ST/SG/AC.10/C.3/2008/5/Add.1  
13 March 2008

**MISCELLANEOUS PROPOSALS OF AMENDMENTS TO THE MODEL REGULATIONS  
ON THE TRANSPORT OF DANGEROUS GOODS**

Amendment to paragraphs 6.7.2.6 and 6.7.3.6

Addendum

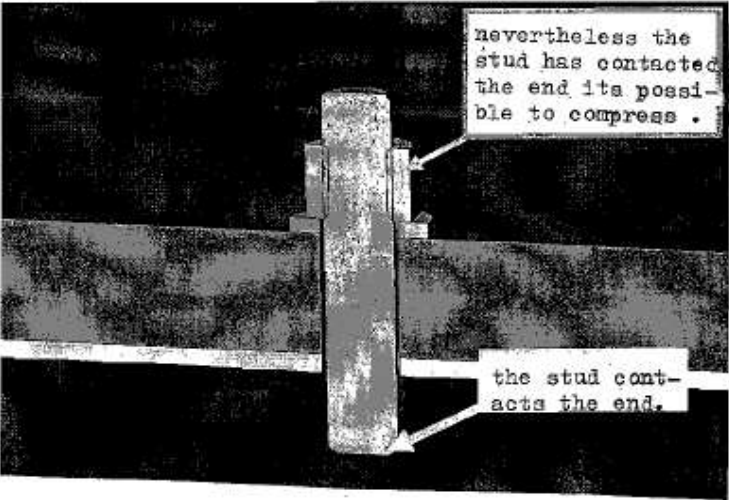
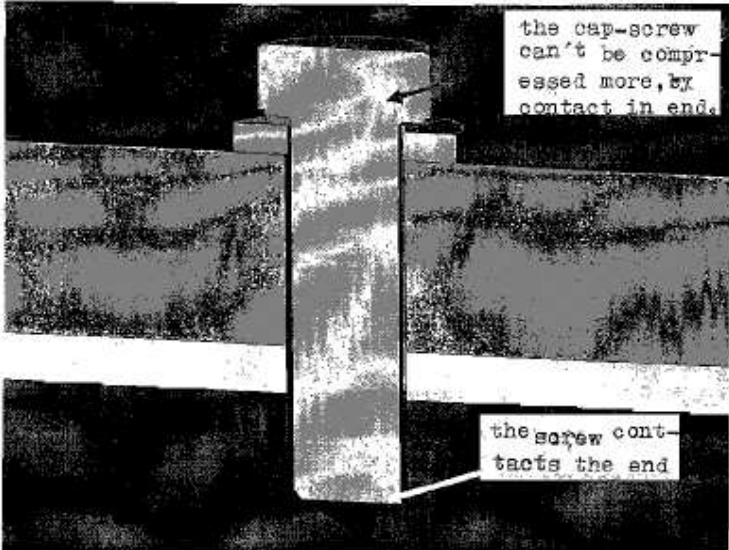
3. The justification for the proposed changes to 6.7.2.6 is that as a result of an accident that took place in Huesca, Spain, on 28 February 2007, the Spanish Government collected information about the closures of the manholes, mainly on portable tanks used to carry dangerous goods of Classes 3 to 9 (not Class 2). The final conclusion was that, when pivoting bolts are used as a closure system, the number of bolts for portable tanks should be specified in the Model Regulations.

Leakage taking place during the overturning of portable tanks in accidents and quite common detention of leakage on the manhole’s covers having 4 or 5 pivoting points during the leakproofness test both demonstrate that the effect of the internal pressure of the tank produces distortion of the cover, which is sometimes very thin for portable tanks. When bolts are used as a closure system, the distance between the pivoting bolts is the reason why this distortion takes place (Standard 14.512 has been taken as reference in the proposal).
